Cameron Road Multi-modal Corridor Project, Engagement Record

Table 2 BOPRC Cameron Rd Multimodal 80% Design Review

Figure 2: Example A: Residential location east of Cameron Road

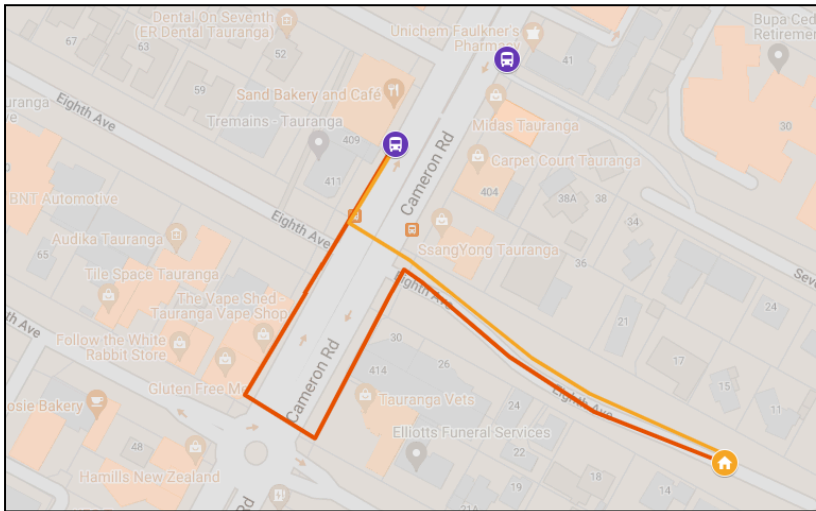
2	<p>Bus stop pair at Seventh and Eighth Ave (General Arrangement Layout Plan Sheet 8 and 9)</p> <p>The bus stop pair between Seventh and Eight Avenues has inadequate facilities for crossing Cameron Road. The nearest crossing points for these bus stops are Ninth Ave, 122 metres away, or Sixth Ave, 119 metres away. This will result in unacceptably long delays for bus passengers and reduce the attractiveness of using public transport. It is also likely to result in pedestrians crossing informally around 7th avenue, which presents safety risks for pedestrians. The impact on example destinations is outlined in Appendix 2. For many locations, lack of a crossing will double walk times to bus stops.</p> <p>This advice is in alignment with <i>the Draft Public Transport Design Guidelines (NZ Transport Agency, publication forthcoming 2021)</i> which state “Ideally, a crossing facility is provided in</p>

Figure 2 below outlines the walking route taken to the northbound bus stop for a residential location east of Cameron Road. The lack of a direct crossing facility near the bus stop nearly doubles the bus stop passenger’s walking time, from 2.7 minutes to 4.9 minutes, before accounting for delays caused by waiting at traffic signals. Figure 3 below outlines the walking route taken to the southbound bus stop for a work location west of Cameron Road. The lack of a direct crossing facility near the bus stop nearly doubles the bus stop passenger’s walking time, from 2.7 minutes to 4.9 minutes, before accounting for delays caused by waiting at traffic signals. Calculations for both examples are outlined in Table 1.

<p>close proximity (100m) of a bus stop, irrespective of if the crossing is controlled or uncontrolled.”</p> <p>Proposed Action/Resolution</p> <p>Option A: Install a mid-block pedestrian crossing between Seventh and Eighth Avenue</p> <p>OR</p> <p>Option B: Move the bus stop pair at Seventh and Eighth Avenue to be immediately north of the intersection of Cameron and Ninth Avenue. This would also require moving the bus stop pair between Ninth and Tenth Avenues southward to maintain even bus stop spacing.</p>		
3	<p>Treatment for eastern cycle path at high-use driveways (Main Works Construction Details Sheet 9)</p> <p>Driveways are a conflict point between cyclists and motor vehicle users. The risk of a crash or near miss increases in areas with high-use driveways, high cycling volumes, and high cycling speeds. There are several high-use driveways on the east side Cameron Road that have a heightened risk of conflict, including the PAK’nSAVE supermarket, the Mobil service station, and the Countdown supermarket.</p> <p>While the <i>Main Works Construction Details</i> document states that speed cushions will be provided at high use driveways, it is unclear if other recommended treatment elements have been included. These additional recommended treatment elements include: limit line, bi-directional cycle signs (WU61) facing vehicles exiting, and green bar markings that extend to the full width of the driveway.</p> <p>Proposed Action/Resolution</p> <p>Ensure that the design is consistent with the recommendations outlined in <i>High-use Driveway Treatment for Cycle Paths and Shared Paths</i> (NZ Transport Agency, 2019).</p>

Figure 5: Two-way cycleway bus stop design recommended by Waka Kotahi (publication forthcoming 2021)

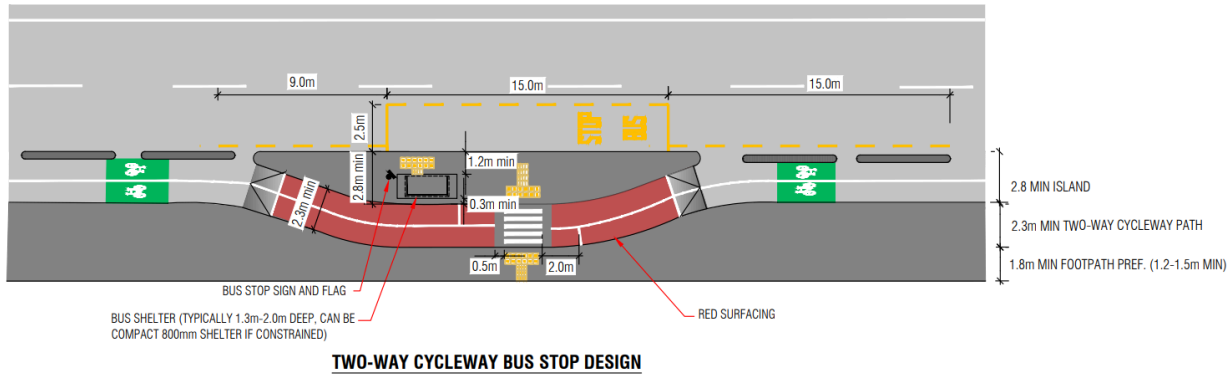
4	<p>Bus stop bypass design (Main Works Construction Details Sheet 4)</p> <p>The <i>Main Works Construction Details</i> document outlines a bus bypass design that has cyclists and pedestrians using a shared path behind a kerbside bus stop and shelter. This type of design is not in alignment with <i>the Draft Public Transport Design Guidelines</i> (NZ Transport Agency publication forthcoming 2021)</p> <p>Proposed Action/Resolution</p> <p>Option A (preferred): Revise the design to reflect the recommended bus bypass design for two-way cycle paths outlined in <i>the Draft Public Transport Design Guidelines</i> (NZ Transport</p>

<p><i>Agency, publication forthcoming 2021</i>). These are shown in the Appendix. Under this scenario, minimum footpath and cycle path widths must be achieved for safe operation.</p> <p>OR</p> <p>Option B: If a shared space type design is used at bus stops, the shared area should be painted with red paint to alert users that it is a conflict area. An example is shown in Appendix 4.</p>		
5	<p>Crossing design</p> <p>The design uses a two-way cycle path on the eastern side of Cameron Road. Due to this design and the large, divided nature of the corridor, cyclists will need to use the provided crossing facilities to move between the cycle path and destinations on the western side of Cameron Road. The <i>Cycling Network Guidance (Waka Kotahi)</i> states that “segregated crossings are more appropriate where there are high volumes of pedestrians and/or cyclists. They also allow for the shorter signal phase for cyclists to run separately from the pedestrian signal phase, thereby reducing the delays to drivers.” Given that the route is central to the local walking and cycling network, a segregated crossing is likely to provide an improved crossing environment for pedestrians and cyclists.</p> <p>Proposed Action/Resolution</p> <p>Option A (Preferred): Use segregated crossings with a straight cycle crossing, staggered pedestrian crossing and separate pedestrian and cyclist phase lengths. If possible, implement a raised platform type design to improve the crossing experience for pedestrians and cyclists. An example of this type of design is shown in Appendix 5.</p> <p>OR</p> <p>Option B: Use segregated crossings with staggered crossings for both pedestrians and cyclists. If possible, implement a raised platform type design to improve the crossing experience for pedestrians and cyclists. An example of this type of design is shown in Appendix 5.</p>

Figure 10: Traffic volumes and lane capacity (2028 daily maximum)

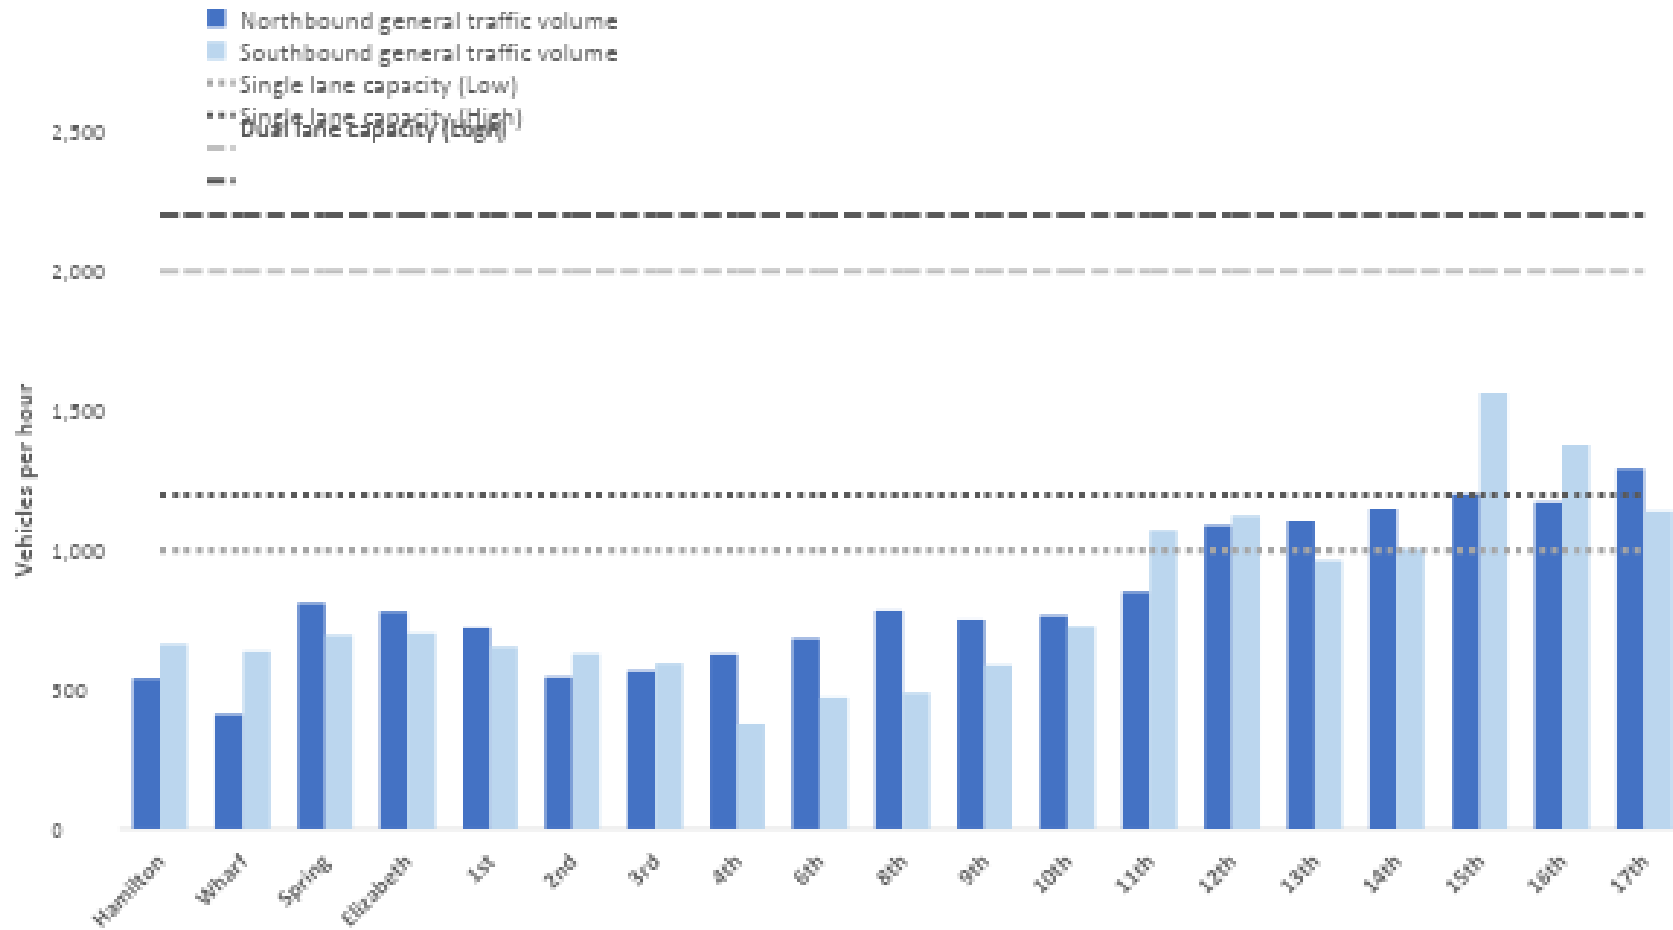
<ul style="list-style-type: none"> o There is limited remaining corridor width available for walking and cycling infrastructure has resulted in a design with a minimum footpath width of 2.4 metres and a minimum two-way cycling path of 3.0 metres. <p>The Cameron Road project will increase road capacity by removing buses from general traffic lanes, removing conflicts with parked cars during peak times, and by implementing left-in-left out turning controls at many intersections and driveways. The <i>Guide to Traffic Management Part 3: Transport Study and Analysis Methods (Austroads, 2020)</i> outlines mid-block capacity for urban arterials with interrupted flow. According to the <i>Guide</i>, the Cameron Road project can be expected to increase road capacity from around 1600 vehicles per hour to 2000 to 2200 vehicles per hour per direction.</p> <p>Furthermore, projected traffic volumes for 2028 indicate that two lanes of traffic in each direction is not required along the length of the project. Estimated peak traffic volumes and lane capacity are outlined in Appendix 7. From 11th Avenue to Elizabeth St, one traffic lane per direction is sufficient to accommodate demand. One other sections of the corridor, only moderate levels of traffic reduction (either through mode shift or re-routing to other corridors) would be required for effective one lane operation per direction.</p> <p>Proposed Action/Resolution Option A (Preferred): Revise the design to reduce general traffic lanes from two lanes to one lane per direction from Wharf Street to Eleventh Avenue, as projected 2028 traffic volumes indicate that one lane per direction is sufficient to accommodate 2028 general traffic volumes. From Wharf Street to Eleventh Avenue, use the additional space available to increase space allocation for pedestrians, cyclists, and green space.</p> <p>OR</p> <p>Option B: Use the construction period of any enabling works to trial one lane operation per direction for general traffic. If the trial is successful, revise the design to reduce general traffic lanes and increase space allocation for pedestrians, cyclists, and green space.</p>

Figure 12: Proposed Queue Jump on Cameron Road

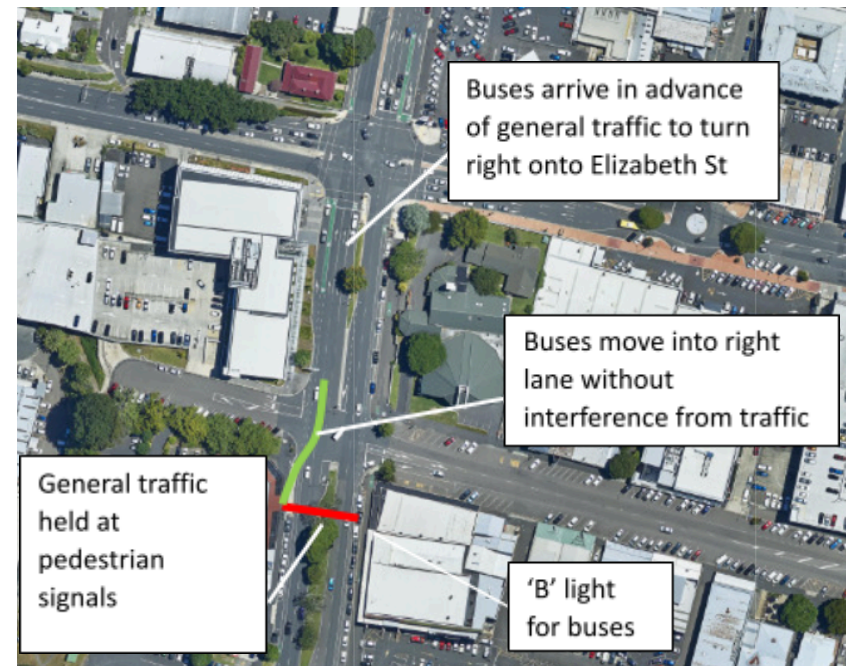
<p>Most northbound buses travelling on Cameron Road turn right onto Elizabeth Street. This manoeuvre requires moving from a kerbside bus lane across two lanes of general traffic to a centre right turn lane. Crossing two lanes of general traffic without bus priority will cause delays for bus passengers.</p> <p>Proposed Action/Resolution Install a pedestrian signal with a bus queue jump between around 1st and 2nd Ave, somewhere after the bus stop beyond Third Ave. This will significantly reduce delays to bus passengers by eliminating conflict with general traffic and allowing buses to arrive first to the Elizabeth St intersection. It also provides a benefit of improved pedestrian access provided by an additional crossing point. A further explanation is provided in Appendix 8.</p>		
9	<p>Bus priority measures at Eleventh Avenue intersection (General Arrangement Layout Plan Sheet 7) At the Eleventh Avenue intersection, there are very high left turning volumes on the southern approach, with 590 left turning vehicles per hour projected for the PM peak in 2028. The proposed design separates left turning vehicles from buses, which have their own through lane. However, general traffic going straight through the intersection may use the bus lane as the bus priority at the intersection is unclear, only being marked with a green lane line.</p> <p>Proposed Action/Resolution In the bus lane on the south approach to the intersection, add a bus lane symbol immediately before the white limit line.</p>

A queue jump is a bus priority measure that where a public transport vehicle enters an intersection in advance of other traffic which reduces delays for public transport. Queue jumps be used to assist public transport vehicles in making difficult turns such as a right turn across multiple lanes of traffic. Figure 12 below shows an example from Wellington where a queue jump at a signalised pedestrian crossing allows buses to move from a left kerbside lane to a right centre lane, avoiding delays caused by conflicts with traffic. Figure 13 shows how a Queue Jump might be implemented on Cameron Road.
